**PRELIMINARY AND
FINAL DRAINAGE PLAN
PUD/SP**

22-003

**CREEKSIDE SOUTH AT
LORSON RANCH FILING NO. 2**

MAY, 2022

Overflow Swale

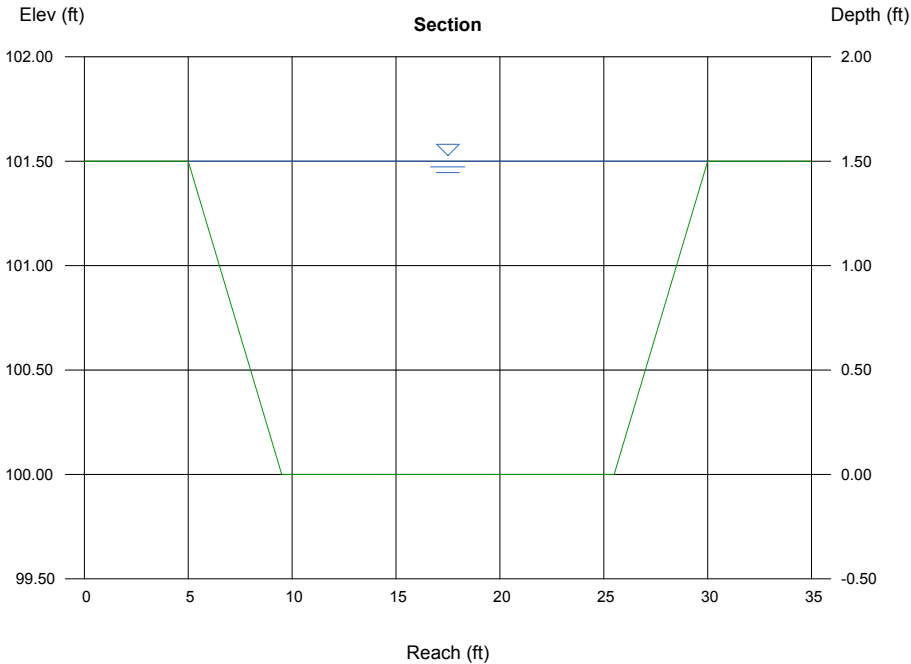
Where was this flow obtained from?
Provide small discussion of this
facility in report.

Where was this flow obtained from? Provide small discussion of this facility in report.

APPENDIX D – POND AND ROUTING CALCULATIONS

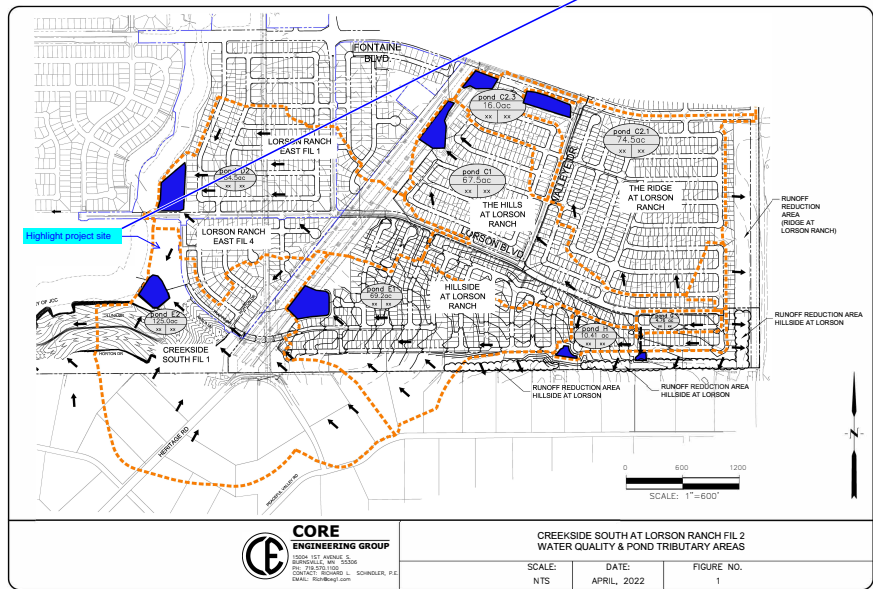
Provide copies of MHFD
pond spreadsheets to
show ponds still function as
designed.

Provide copies of MHFD pond spreadsheets to show ponds still function as designed.

Author: RSchindler Subject: Sticky Note Date: 6/28/2022 4:17:59 PM
spreadsheets added

Hydraflow Plan View

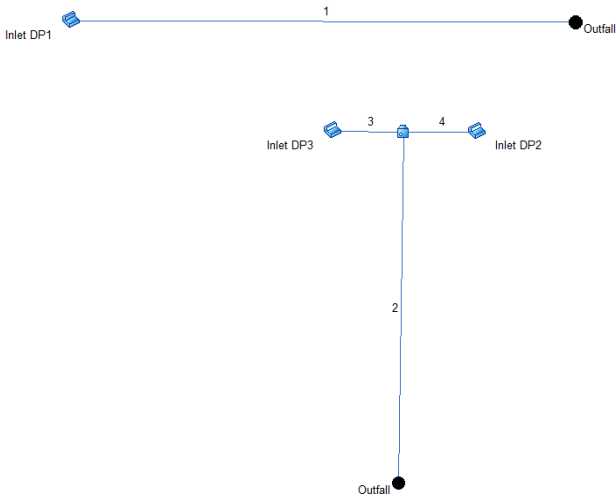
Line No.	Line ID	Flow rate (cfs)	Line size (in)	Line length (ft)	Invert EL Dn (ft)	Invert EL Up (ft)	Line slope (%)	HGL down (ft)	HGL up (ft)	Minor loss (ft)	HGL Junct (ft)	Dns line No.
1		1.10	18 c	123.0	5704.30	5705.53	1.000	5704.70	5705.93	0.13	5705.93	End
2		6.20	24 c	85.0	5701.16	5702.44	1.506	5702.04	5703.32	n/a	5703.32	End
3		2.10	18 c	17.5	5703.40	5703.58	1.030	5703.85	5704.14	0.19	5704.33	2
4		4.10	18 c	17.5	5703.40	5703.58	1.030	5704.05	5704.40	0.27	5704.67	2
					5702.60 to match CD's							
96.4 ft to match CD's

Author: CDurham	Subject: Callout	Date: 6/1/2022 2:08:05 PM
5702.60 to match CD's		
Author: RSchindler	Subject: Sticky Note	Date: 6/28/2022 4:18:47 PM
model updated		
Author: CDurham	Subject: Callout	Date: 6/1/2022 2:23:06 PM
96.4 ft to match CD's		
Author: RSchindler	Subject: Sticky Note	Date: 6/28/2022 4:18:56 PM
model updated

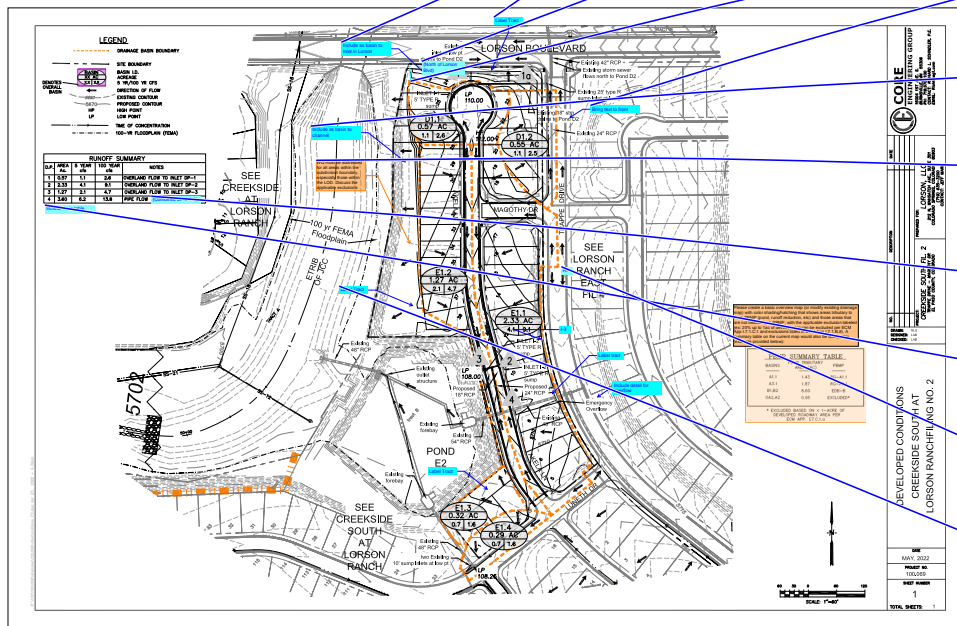
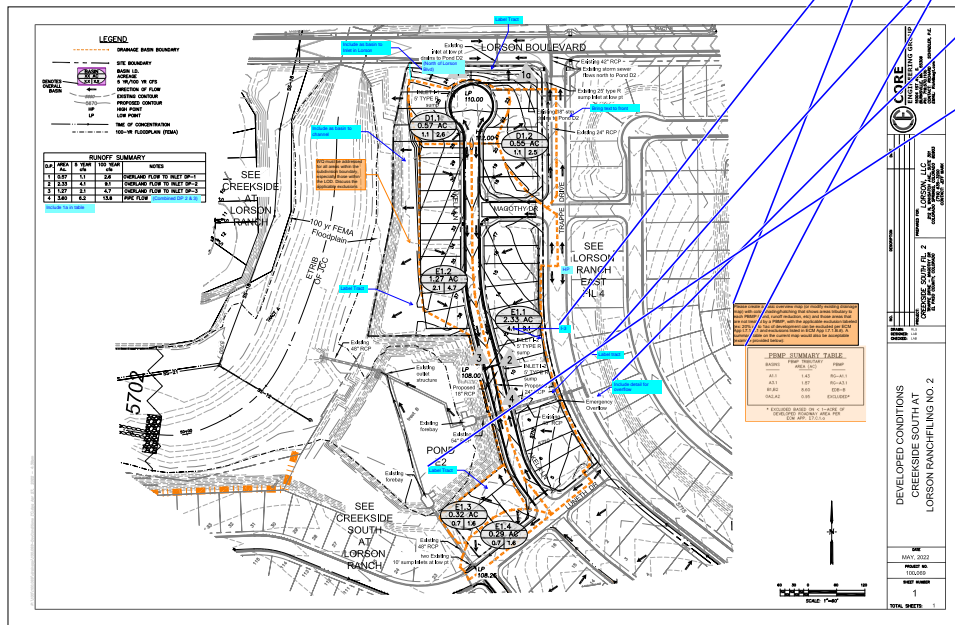
Author: CDurham Subject: Callout Date: 6/1/2022 2:17:37 PM
Label Tract

Author: CDurham Subject: Callout Date: 6/1/2022 12:42:17 PM
Include as basin to Inlet in Lorson

Author: CDurham Subject: Text Box Date: 6/1/2022 12:42:29 PM
(North of Lorson Blvd)

Author: CDurham Subject: Callout Date: 6/1/2022 12:42:45 PM
Bring text to front

Author: CDurham Subject: Callout Date: 6/1/2022 12:41:37 PM
Include as basin to channel

WQ must be addressed for all areas within the subdivision boundary, especially those within the LOD. Discuss the applicable exclusions

Author: CDurham Subject: Text Box Date: 6/1/2022 12:40:34 PM
(Combined DP 2 & 3)

Author: CDurham Subject: Callout Date: 6/1/2022 2:28:49 PM
Label Tract

- Author: Glenn Reese - EPC Stormwater Subject: SW - Textbox Date: 5/26/2022 2:21:12 PM
- Please create a basic overview map (or modify existing drainage map) with color shading/hatching that shows areas tributary to each PBMP (pond, runoff reduction, etc) and those areas that are not treated by a PBMP, with the applicable exclusion labeled (ex: 20% up to 1ac of development can be excluded per ECM App I.7.1.C.1 and exclusions listed in ECM App I.7.1.B.#). A summary table on the current map would also be acceptable (example provided below):

- revised
- Author: Glenn Reese - EPC Stormwater Subject: Image Date: 5/26/2022 2:21:12 PM
- Author: CDurham Subject: Callout Date: 6/1/2022 2:17:12 PM
- Label tract

- Author: RSchindler Subject: Sticky Note Date: 6/28/2022 4:23:46 PM
- added
- Author: CDurham Subject: Callout Date: 6/1/2022 2:17:10 PM
- Include detail for overflow

- Author: RSchindler Subject: Sticky Note Date: 6/28/2022 4:23:53 PM
- section added
- Author: CDurham Subject: Callout Date: 6/1/2022 2:29:08 PM
- Label Tract

Author: RSchindler Subject: Sticky Note Date: 6/28/2022 4:23:06 PM
added

Author: RSchindler Subject: Sticky Note Date: 6/28/2022 4:22:40 PM
added

Author: RSchindler Subject: Sticky Note Date: 6/28/2022 4:22:49 PM
added

Author: RSchindler Subject: Sticky Note Date: 6/28/2022 4:23:42 PM
text moved to front

Author: RSchindler Subject: Sticky Note Date: 6/28/2022 4:21:26 PM
basin added

Author: RSchindler Subject: Sticky Note Date: 6/28/2022 4:22:07 PM
basin added and WQ discussed.

Author: RSchindler Subject: Sticky Note Date: 6/28/2022 4:21:20 PM
note added

Author: RSchindler Subject: Sticky Note Date: 6/28/2022 4:22:30 PM
added

- Author: RSchindler Subject: Sticky Note Date: 6/28/2022 4:24:08 PM
- table added
- Author: CDurham Subject: Callout Date: 6/1/2022 12:43:22 PM
- I-3
- Author: RSchindler Subject: Sticky Note Date: 6/28/2022 4:23:13 PM

- Author: RSchindler Subject: Sticky Note Date: 6/28/2022 4:23:02 PM
- added
